Access Compliance Report

Public Rights-of-Way

Intersection ID: 42365	Main Street: CARDINALS_NEST_DR	Cross Street: KESTRAL_RIDGE_DR	Location: NW
ADA ID: 713D38C493C2	Ramp Type: BlendTrans1	Initial Pass/Fail: Fail	Overall Compliance: No
		Severity Score: 8.75

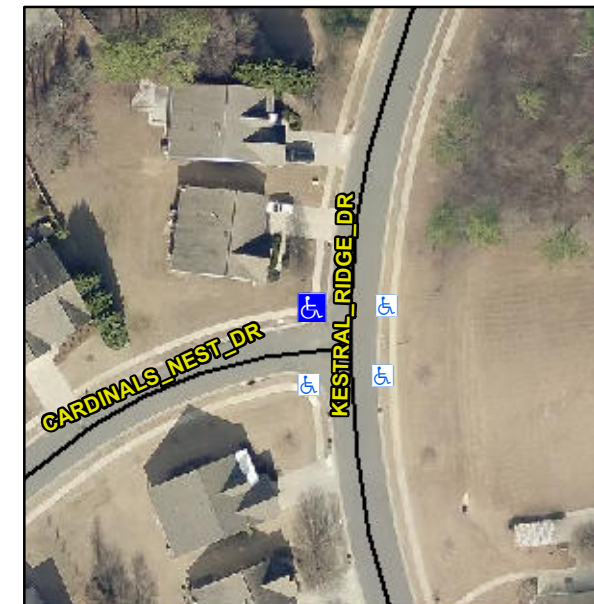
Not Found, R304.5.1

Compliance	Description	Data	Compliance	Description	Data
N/A	Ramp Length (in)	47.0	Yes	BlendTrans Slope (%)	4.6
No	Ramp Width (in)	46.0	Yes	BlendTrans XSlope (%)	0.2
N/A	Flare Type LT	N/A	N/A	Flare Type RT	N/A
N/A	Flare Slope LT (%)	N/A	N/A	Flare Slope RT (%)	N/A
N/A	Flare Traversable LT?	N/A	N/A	Flare Traversable RT?	N/A
N/A	Landing Length (in)	N/A	N/A	DWS Provided?	N/A
N/A	Landing Width (in)	N/A	N/A	DWS Contrast?	N/A
N/A	Landing Slope (%)	N/A	N/A	DWS Length (in)	N/A
N/A	Landing X Slope (%)	N/A	N/A	DWS Full Width?	N/A
N/A	Landing Curb? (Y/N)	N/A	N/A	DWS Offset (in)	N/A
N/A	Shared Landing?	N/A			
N/A	Gutter Ponding?	N/A	N/A	Gutter Slope (%)	N/A
N/A	Gutter Lip Ht (in)	N/A	N/A	Gutter X Slope (%)	N/A
N/A	Painted X Walk1?	No	N/A	Painted X Walk2?	No
	X Walk 1 Direction	To S		X Walk 2 Direction	To E
	X Walk 1 Width (in)	N/A		X Walk 2 Width (in)	N/A
	X Walk 1 Slope (%)	0.8		X Walk 2 Slope (%)	3.1
	X Walk 1 X Slope (%)	0.0		X Walk 2 X Slope (%)	1.0

N/A	Ramp inside XWalk1?	N/A	N/A	Ramp inside XWalk2?	N/A
	Road Slope (%)	0.2		Clear Space?	N/A
	Road X Slope (%)	0.2	N/A	Clear Space to XWalk (in)	N/A
N/A	Any Obstructions?	N/A	N/A	Storm Grate/Utility Hazard?	N/A
	Obstruction Type			Storm Grate/Utility Type	
		N/A			N/A
			Yes	Surface Condition? (G/P)	Good
			No	Curb Slope (%)	21.4

Remove & Replace Curb Ramp With Two New Directional Ramps or Equivalent.
